Response to Submissions Received

1502 – Politis Hunter Development

DA2016/00267
12 Stewart Avenue
Newcastle West, NSW

Appendix B – Response from Landscape Architect

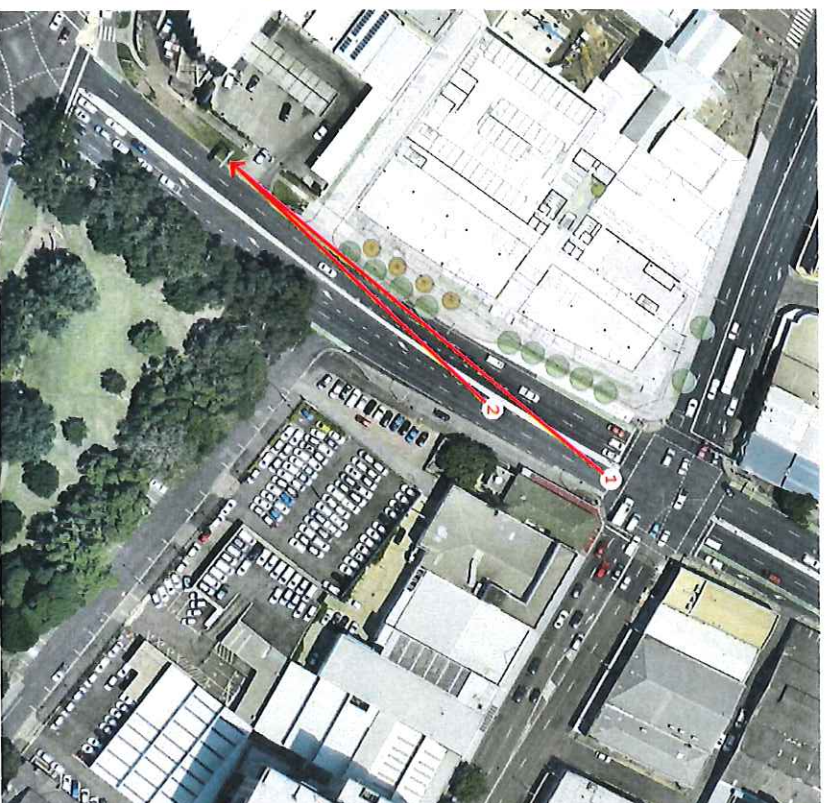
A preliminary assessment for acid sulphate soils prepared in accordance with the Acid Sulfate Soils Manual in the event that site works are going to occur at depths of 2m or more below natural ground level. Street trees along Stewart Avenue are indicated on the Landscape plans to be in the order of 5-6m high. This will potentially obscure our current site signage for the Car Lovers site when travelling south. Can evidence be provided that the proposed street trees will not adversely impact on the current Car Lovers signage exposure.

The *Caesalpinia ferrea* is an evergreen tree with a wide, flat-topped crown; it can grow 10 - 15 metres tall.
The canopy is sparse which will allow for visibility through the canopy.

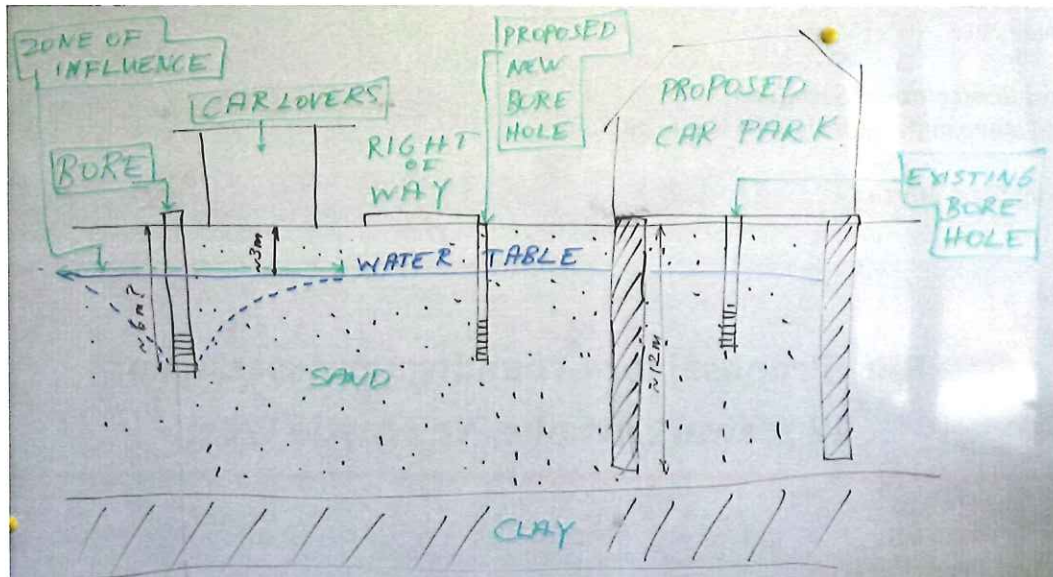
The current carwash facility at Car Lovers utilises bore water as its main water source. We have concerns that the proposed development may effect this water supply again during construction as it did with the development on the corner site that is owned by the same company & I believe that the same builder is being considered to carry out the project. This resulted in serious damage to the Carlovers Carwash water purification system, numerous pumps & motors & the actual bore system itself. Many times during construction our business was closed & or interrupted as we had no water supply. What precautions are to be implemented during construction to ensure that there is no adverse impact on the current underground water supply. I would like to have the opportunity to view all underground plans etc before a DA is approved, especially concrete injected piers that enter or pass through the water table. I would also wish to explore the concept of a bond being put in place to cover any damage done to the aquifer because when this happened before Carlovers Carwash had to fund all repairs & losses, a large amount of money, for a long period of time before a satisfactory settlement was reached.

The objective of the project is to assess the potential for the adjacent private bore to be affected by the installation of the concrete piles during the construction stage. To do this we are proposing a pumping test on the car lovers bore to gather baseline data prior to construction on:

The test will have two purposes, firstly it will provide predevelopment information which will serve as a baseline against which to compare against during construction. Secondly, the pumping test will provide an indication of the zone of influence (also known as 'zone of drawdown' or 'cone of depression') that occurs around the Car Lovers bore when pumping and the potential for this zone to extend into the adjacent construction site. The concept of the zone of influence is shown in the graphic below, which represents a cross section through the subject sites.
